Subject: 2007 Annual Radioactive Effluent Release Report

## Indian Point Energy Center

## 2007 Annual Radioactive Effluent Release Report

Addendum 1, ODCM changes and justification packages, 2007

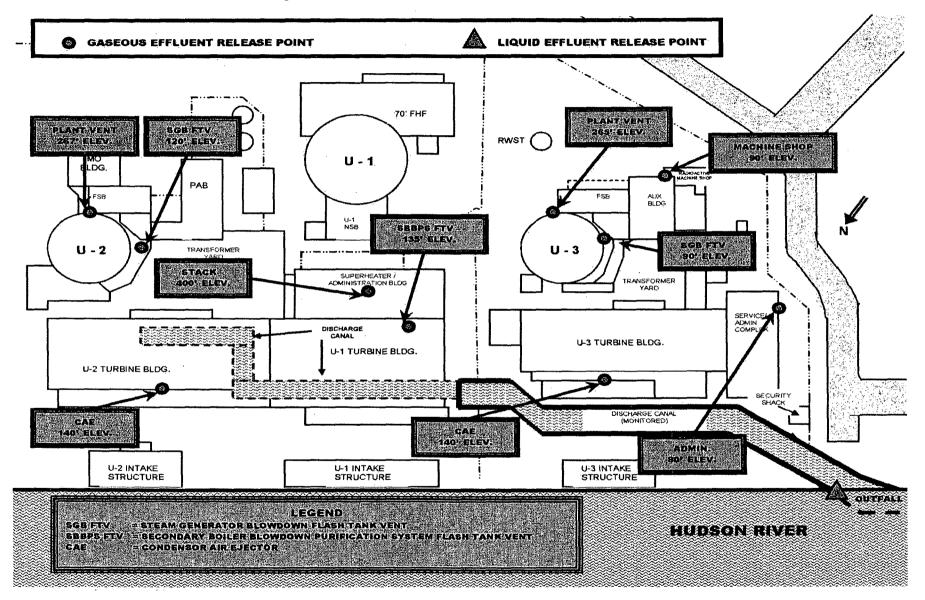
Expand / update Figure 1-1 into two figures (adding 1-2), to show greater detail with regard to the release points and site boundary.

#### Figure 2-1

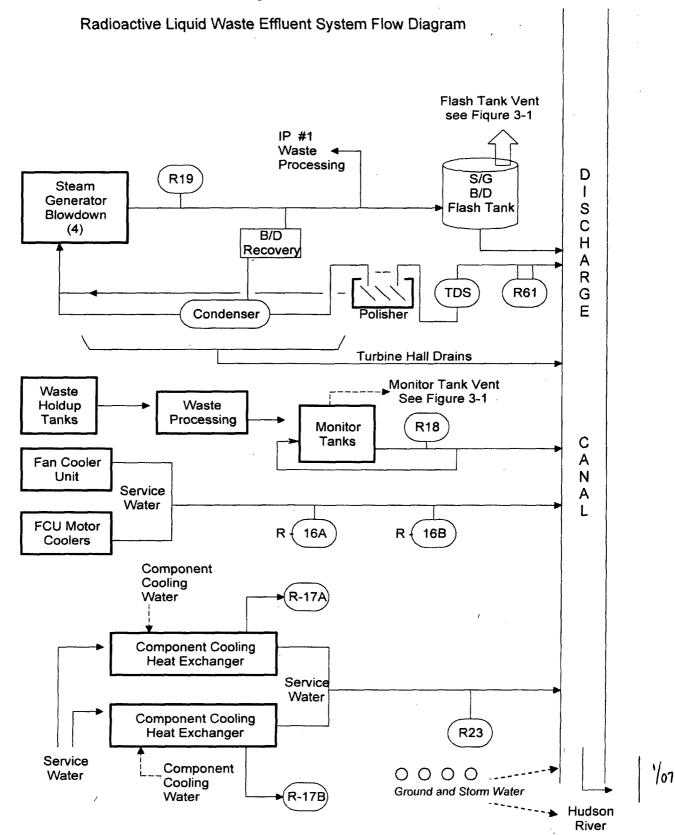
Add ground and storm water representation to Figure 2-1.

Add the representation of ground and storm water pathways to the figure of liquid effluent pathways.

## FIGURE 4-1

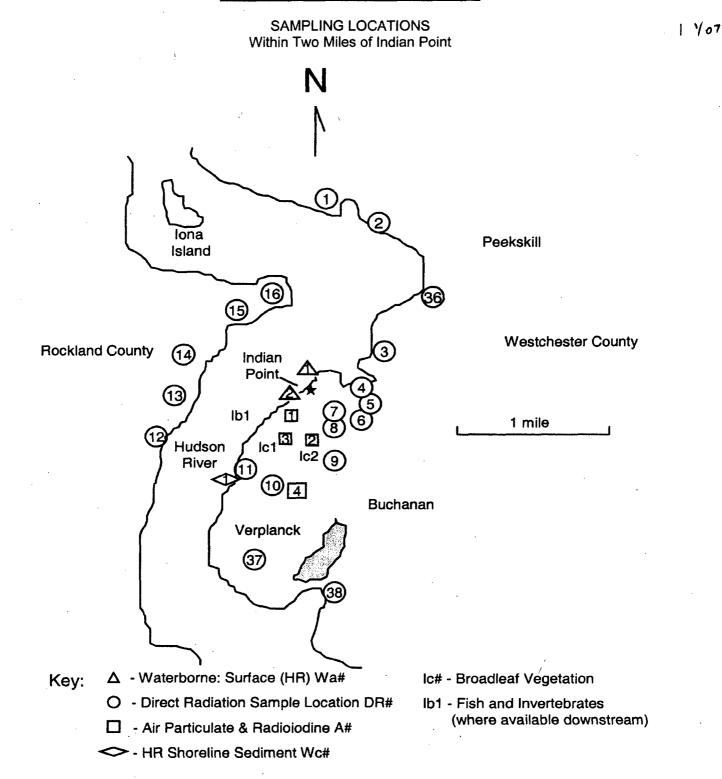
Add a paragraph in Section 4.0 describing the interface between the REMP and the GWMP.

Remove "RECS" from the title of Figures 4-1, 4-2, 4-3, and Table 4-1.

A paragraph was added at the end of this section to ensure clarity regarding the boundary and interface between the REMP and the Ground Water Monitoring Program. This added verbiage identifies that the GWMP is defined on site with station procedures and program documents (SMM), in a similar fashion to NEM procedures that implement the REMP.
